Review 1

John & Maryan, LLC
Preliminary and Final Major Site Plan
Application P-24-036
455-461 Avenue C Redevelopment Area

455-461 Avenue C
Block 219, Lot 24.01

March 9, 2025

Figure 6 from the Redevelopment Plan Depicting the Required Yard Widths/Depths.

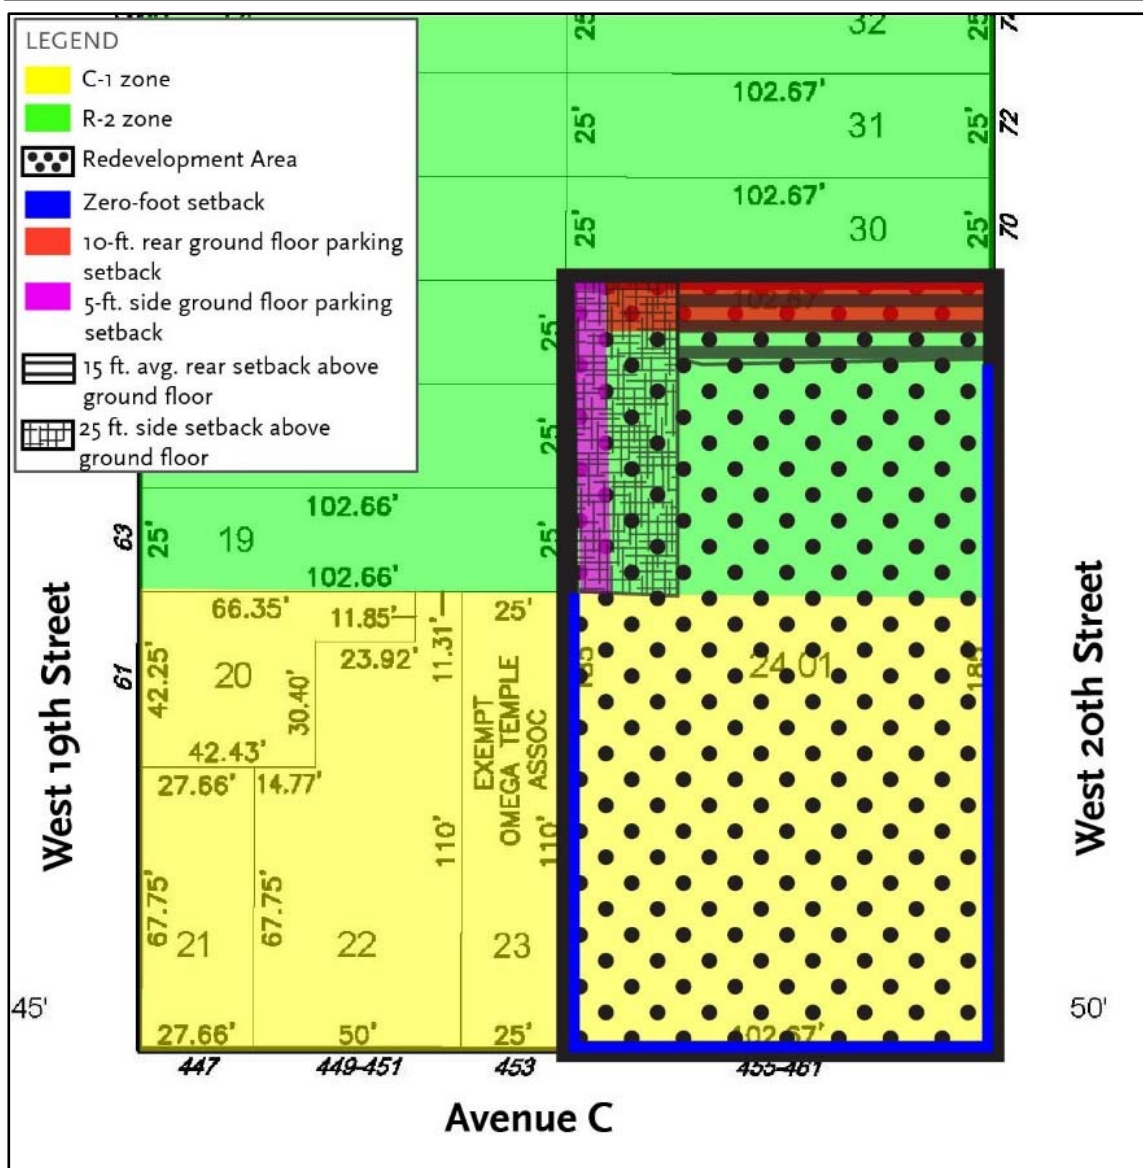
- 3.2. **Minimum Rear Yard Setback Variances.** Figure 6 of the Redevelopment Plan illustrates the required setback areas affecting the property, supplemented by §5.7.A.3, which describes the extent of the required setbacks. For the rear yard, a setback of 10 feet is required from the rear lot line parallel to Lot 30 for the ground floor of the building where it is used for internal parking enclosed within the building. Otherwise the setback shall average 15 ft., though shall not be closer to Lot 30 than 12 ft. All floors above the ground floor, regardless of use, requires a setback that averages 15 ft., which shall not be closer to Lot 30 than 12 ft. Our review of the setbacks indicates the following:

- The ground floor of the building contains parking enclosed within the building. The site plan does not provide a dimension for this setback. The entire length of this building wall scales approximately 12 feet from the rear property line adjoining Lot 30. The site plan should be revised to provide an accurate dimensioning of the setback to ensure compliance with the Redevelopment Plan.

- The second floor contains two areas that are set approximately 12 feet from the rear lot line adjoining Lot 30. The first lies within the area depicted in Figure 6 as requiring a 15-foot setback (northeast corner of the lot) and the second lies within the area depicted in Figure 6 as requiring a 25-foot setback (northwest corner of the lot) and is occupied with a private roof deck. **Variations are required.**
- The third through sixth floors are set back an average of 15 ft.; an area 41'9" long (northeast building corner) is 12 feet from the rear lot line and area 28'1" long (northwest corner) is setback 18'2" from the rear lot line for an average setback of 15 feet.

3.3. **Side Yard Setback – Upper Floor Variations.** Figure 6, reproduced on the following page, illustrates the required setback areas affecting the property, supplemented by §5.7.A.4 which describes the required setbacks. For the side yard on the south side of the property that adjoins Lot 23, there is no required setback except as necessary to provide air and light to windows and/or light wells in adjacent properties (blue area on Figure 6), a five-foot setback adjacent to Lots 17, 18, and 19, and the R-2 zone for the ground floor when the ground floor is used for parking (magenta on Figure 6). All floors above the ground floor, regardless of use, shall require a setback of 25 ft. (thin mosaic lines on Figure 6). Common and private balconies, decks, or other outdoor personal recreational facilities or space shall be permitted within the side yard setback above the ground floor, though shall not be closer than 10 feet to any property line located within a residential district. Outdoor recreation at ground level may be permitted to the property line. The ground floor and third through sixth floors appear to comply with the side yard setback requirements, however the second floor encroaches into the minimum side yard setback as described below:

- The ground floor of the building contains parking enclosed within the building. There is an approximately 24-foot-long section of the building’s ground floor in the southwest corner of the property where it abuts the C-1 District, that provides a zero foot setback. The adjoining building on Lot 23 does not appear to have any existing windows on the wall facing the subject property. The building wall then jogs back from the side property line. The site plan does not provide a dimension for this setback, but measures approximately five feet, along Lots 17, 18 and 19 in the R-2 District. **The site plan should be revised to provide an accurate dimensioning of the setback to ensure compliance.**
- The second floor contains two areas that do not appear to comply with the required side yard setback requirement. The first is along the C-1 District boundary, where

there are private and common area roof decks and a mechanical area that are located within five feet of the side property line, where an at least 10-foot setback is required. The second location is along the R-2 District boundary (and Lots 17, 18 and 19) where private roof decks and a mechanical area are also within five feet of the side property line, where a 25-foot setback is required. Although private and common decks are permitted to encroach within 10 feet of the side yard setback along the R-2 District boundary, it is the mechanical area that is located within ten feet of the property line, not the decks. **A variance is required for each encroachment.**

- No setback is provided along the C-1 District boundary, where it adjoins the existing building Lot 23 on the third through sixth floors. Along the R-2 District boundary, the third through sixth floors are set back 25 feet from the side property line as required.
